# Southwestern Pennsylvania Commission

# *Road Safety Audit*

## Bellefield Avenue

**Oakland Neighborhood, City of Pittsburgh, Allegheny County, PA**

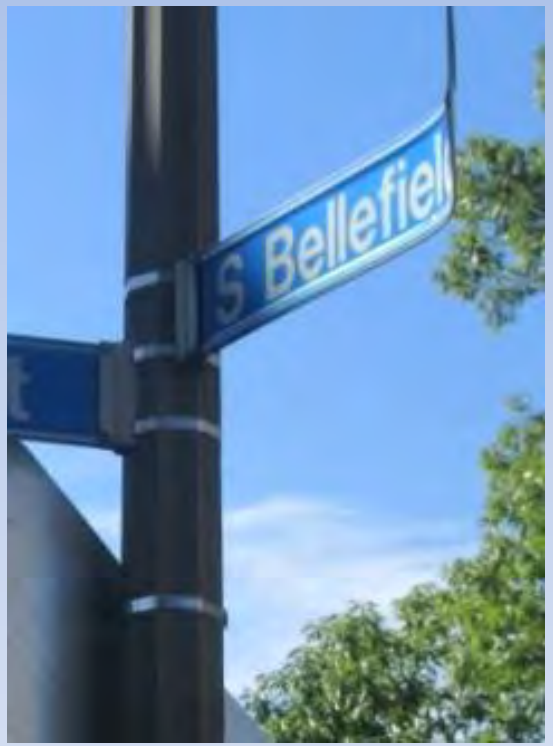
| EXPECTED FREQUENCY | EXPECTED SEVERITY | RISK RATING | |
|---|---|---|---|
| OBSERVATION: Some signs in the corridor have been damaged, defaced or are faded. | | | |

- Replace damaged, defaced and faded signs with new retroreflective signs.
- Replace non-standard signs with MUTCD (Manual on Uniform Traffic Control Devices) standard signs.

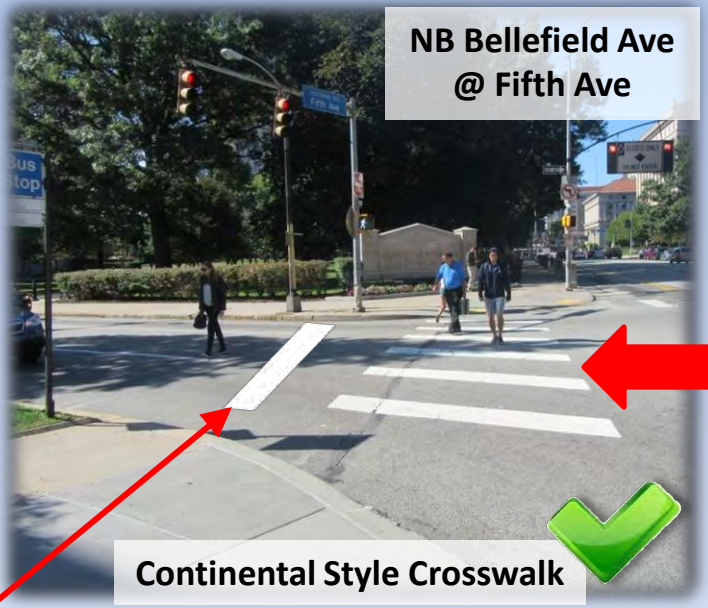
OBSERVATION: Lane designation arrows and stop bars are missing at several locations in the corridor. Crosswalk markings are inconsistent throughout the corridor as well.

- Install lane designation arrows on EB Forbes at Bellefield Ave and on NB Bellefield Ave at Fifth Ave.
- Install Stop Bars at all signalized intersections.
- Install continental ("piano key") style crosswalks of a consistent design at all intersections.

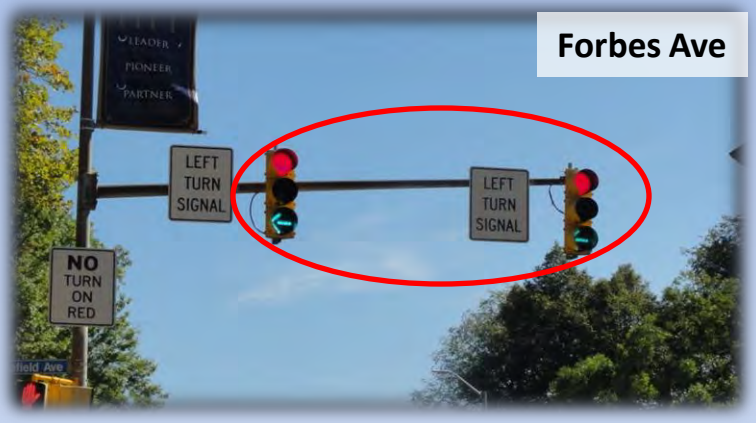
| EXPECTED FREQUENCY | EXPECTED SEVERITY | RISK RATING | |
|---|---|---|---|
| OBSERVATION: Signal heads in the corridor do not have backplates. | | | |

- Install backplates on all traffic signals.
- Consider adding retroreflective tape to signal backplates.

**Remove 3 Parking spaces**

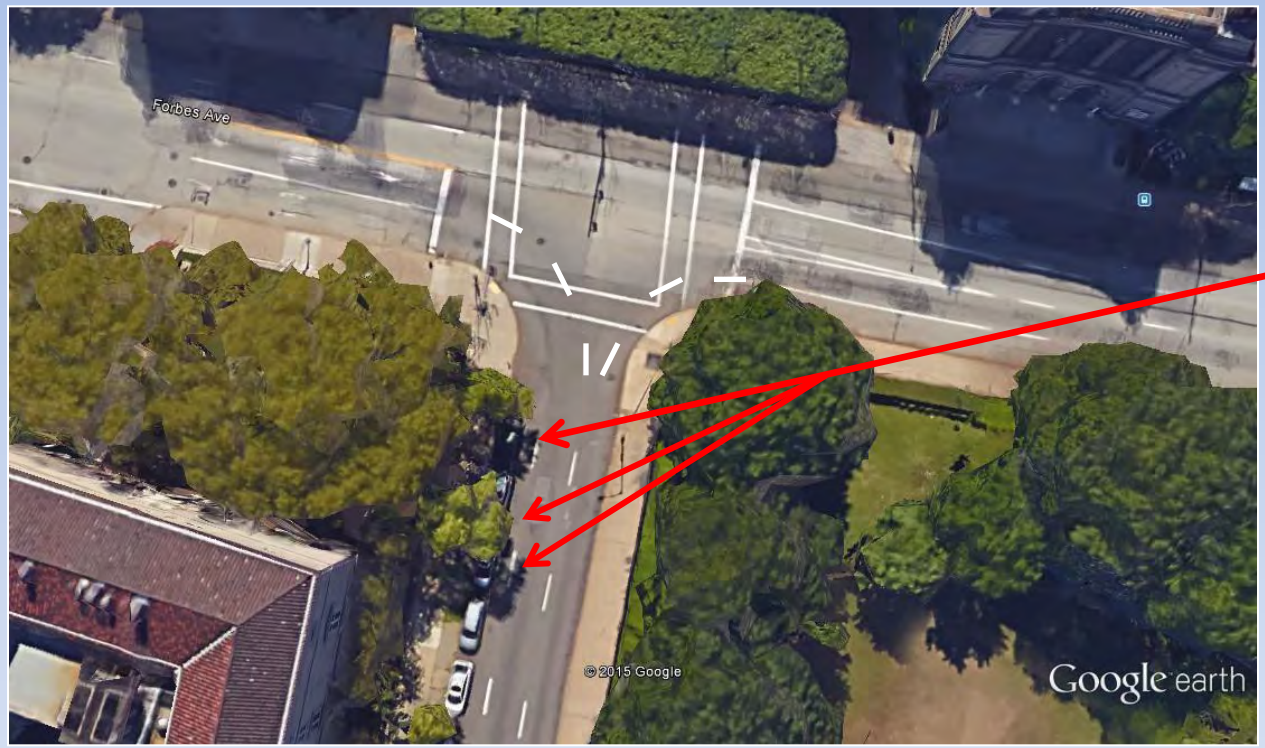
OBSERVATION: Forbes Ave westbound dual left turns and eastbound dual right turns are very tightly spaced and difficult to maneuver. There is no guidance with regard to pavement markings.

- On the east side of Bellefield, remove the three spaces closest to the intersection to create more turning space.
- Provide pavement markings to guide the dual left and right turns from Forbes Ave.

***Bellefield between Fifth and Forbes***

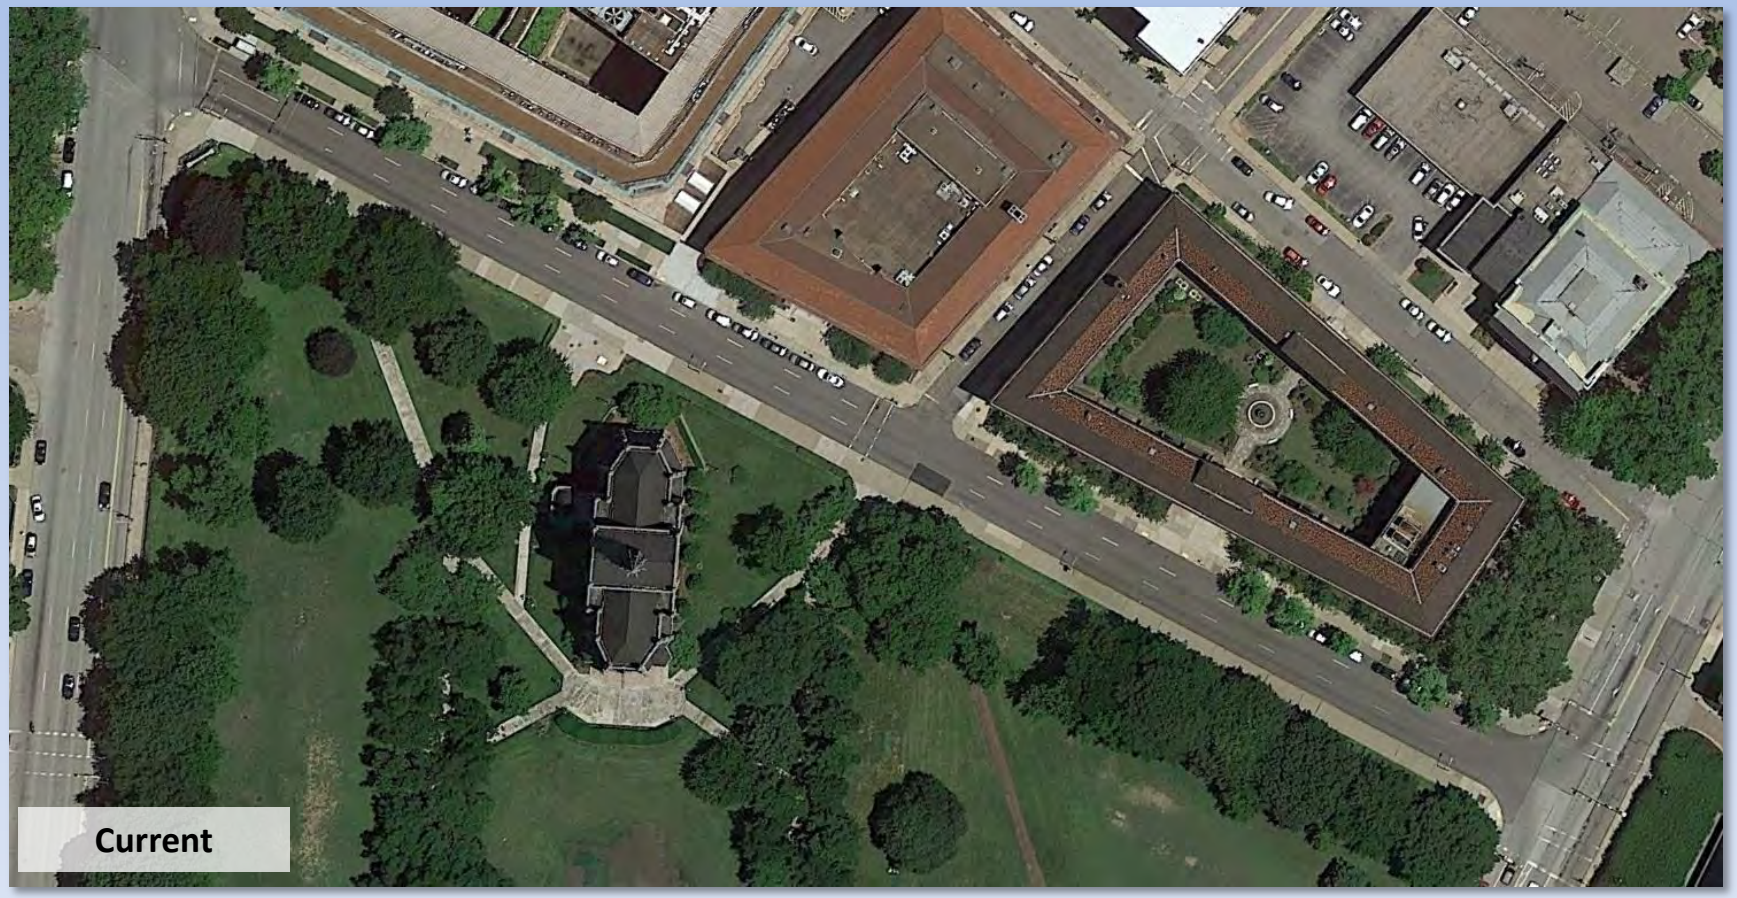
OBSERVATION: Bellefield Ave between Forbes Ave and Fifth Ave is striped as 3 travel lanes but the rightmost lane is always utilized for parking.

- Restripe Bellefield Ave to have two travel lanes and a designated parking lane.

- Provide a 4 foot left shoulder and reduce travel lane width to 12 feet.

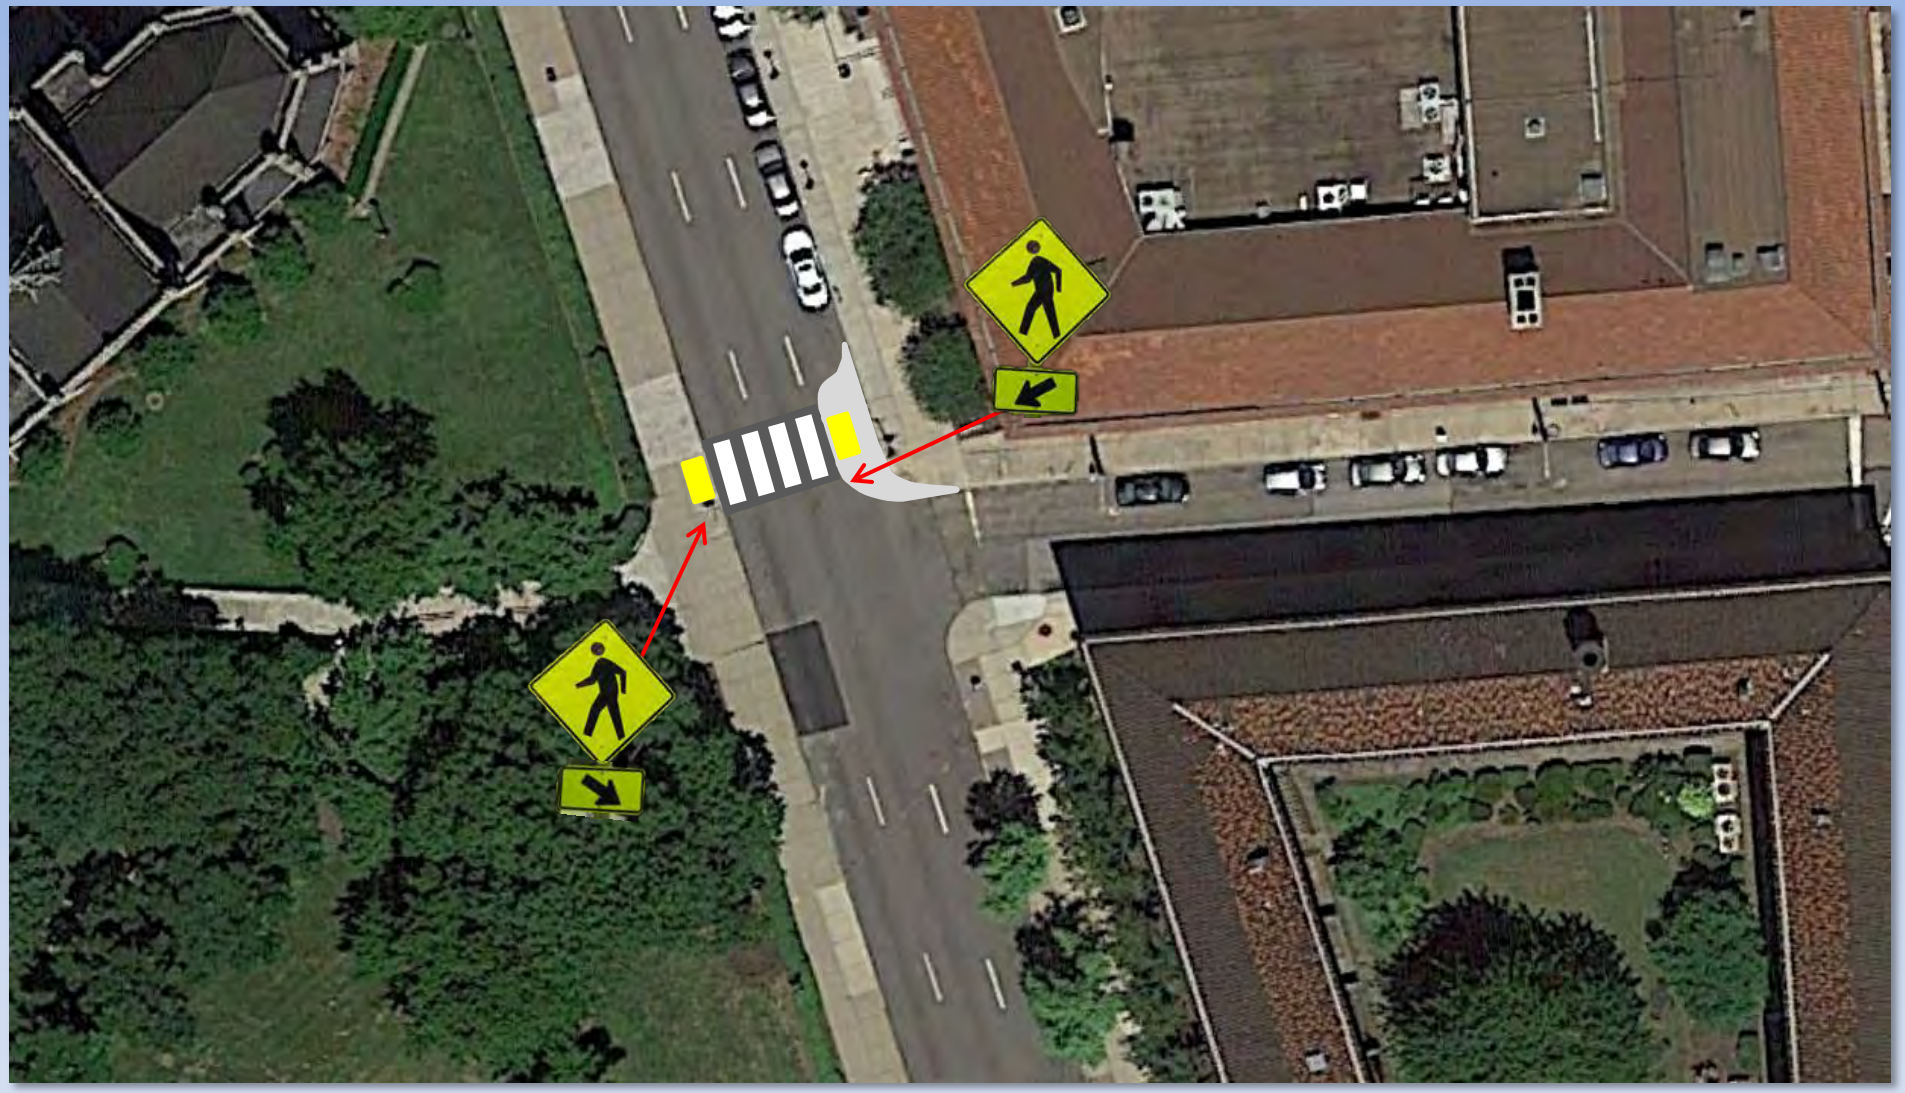
OBSERVATION: A number of pedestrians were observed crossing Bellefield Ave mid-block near Filmore Street. University of Pittsburgh officials noted that Filmore Street is a major pedestrian corridor for students.

- Create a more attractive crossing by:
  - Installing a bulb-out on the eastside of Bellefield Ave at Filmore Street.
  - Installing ADA compliant curb ramps and pedestrian crosswalk signage.
  - Installing pedestrian scale lighting at the upgraded crosswalk.

**Current**

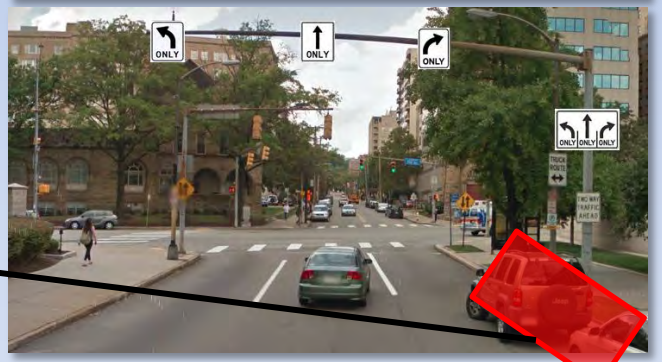
OBSERVATION: Lane assignment is confusing for right and left turns because parking on the east side blocks right lane queue area. Current lane configuration is Left, Thru/Right, Right on NB Bellefield Ave.

- Eliminate 2-3 parking spots on Northbound approach to extend the right turn lane.
- Create dedicated lane arrangement of left, through, and right.
- Include signage and pavement markings clearly stating lane designations.

**Crossing pedestrians are difficult to see**

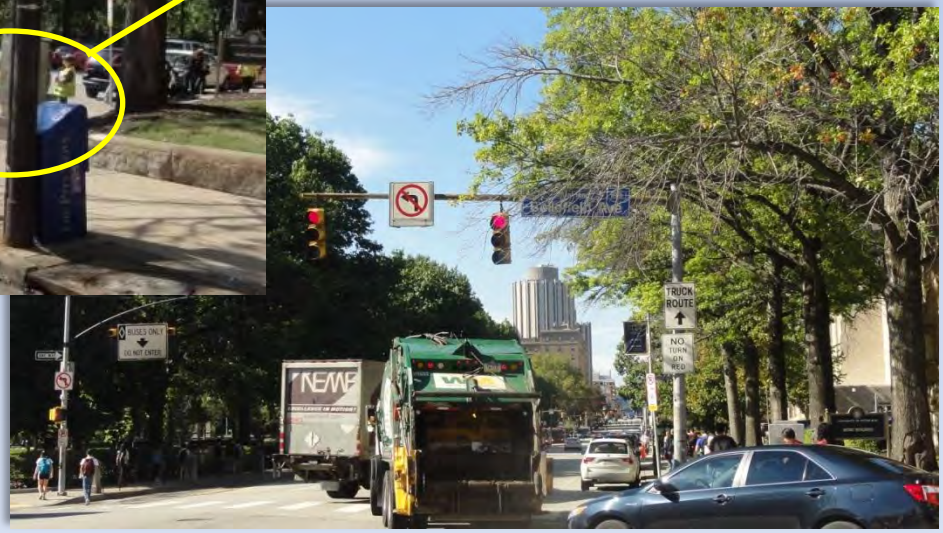
OBSERVATION: The intersection configuration and high volume of pedestrians on the west side of Bellefield at Fifth create a number of pedestrian-vehicular conflicts. It is difficult for drivers heading south on Bellefield and turning right onto Fifth to see crossing pedestrians.

- Implement a “No Turn on Red” for the southbound approach.

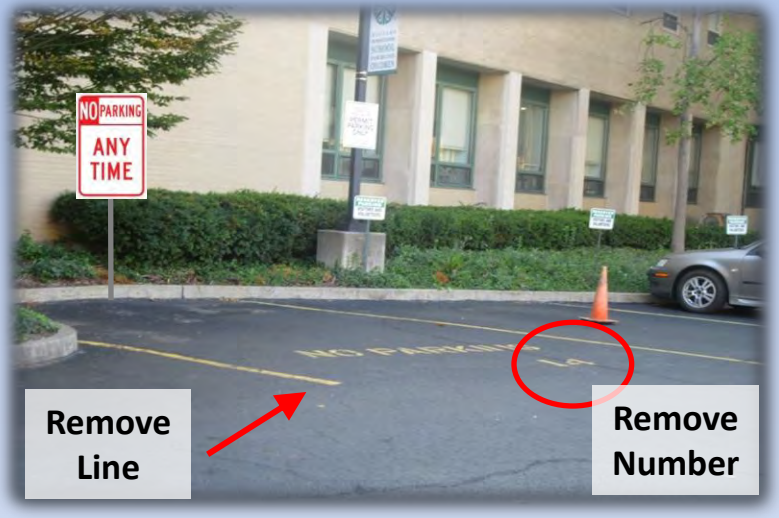
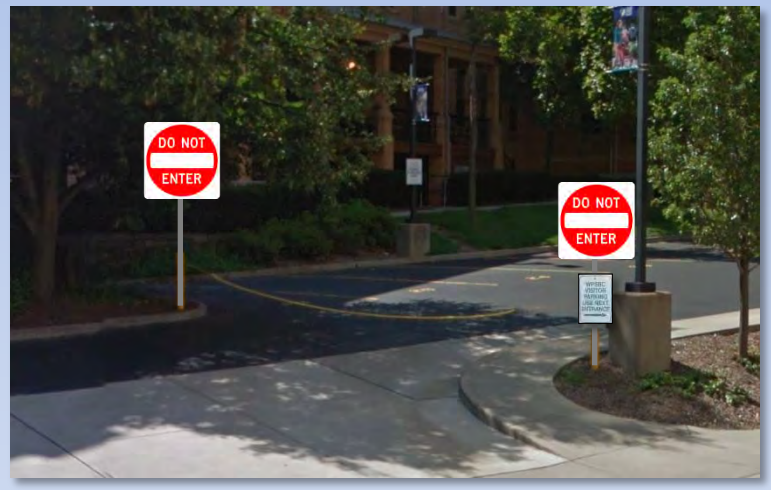
OBSERVATION: The pavement markings in the "no parking" space are conflicting. There is no standard signage stating that the driveway is one-way.

- Remove parking stall line and parking number. Install a No Parking sign and crosshatch the restricted parking area.
- Install Do Not Enter Signage at the driveway exit.

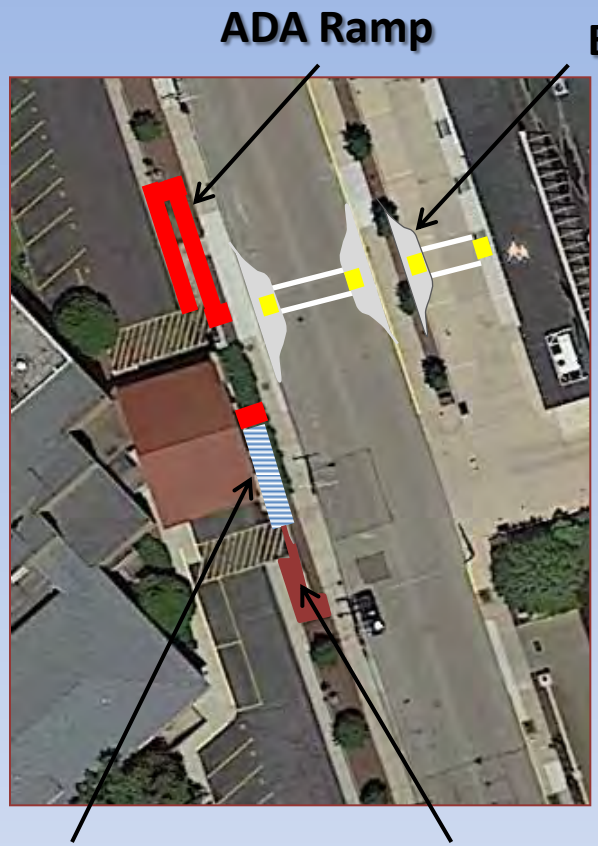
OBSERVATION: Western PA School for Blind Children students and personnel must cross Bellefield Ave but none of the existing unmarked crossing locations are convenient or ADA compliant. The WPSBC strategic plan includes a sky bridge to link the facilities from either side of Bellefield Ave.

- The proposed sky bridge would mitigate this issue. However, If the project does not move forward, an ADA compliant crosswalk and ramps should be constructed in front of the building at a consolidated location.

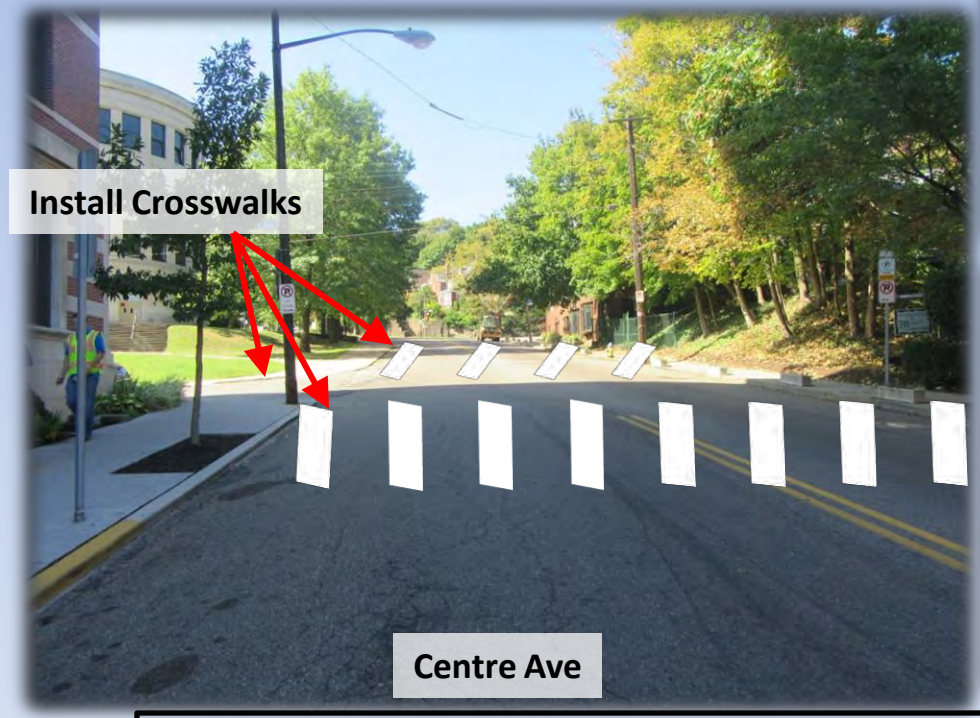
OBSERVATION: Crosswalks and some ADA compliant curb ramps are missing at the intersection of Bellefield Ave and Centre Ave.

- Provide continental ("piano key") style crosswalks at this intersection on all legs.
- Install ADA compliant curb ramps on Centre Ave.
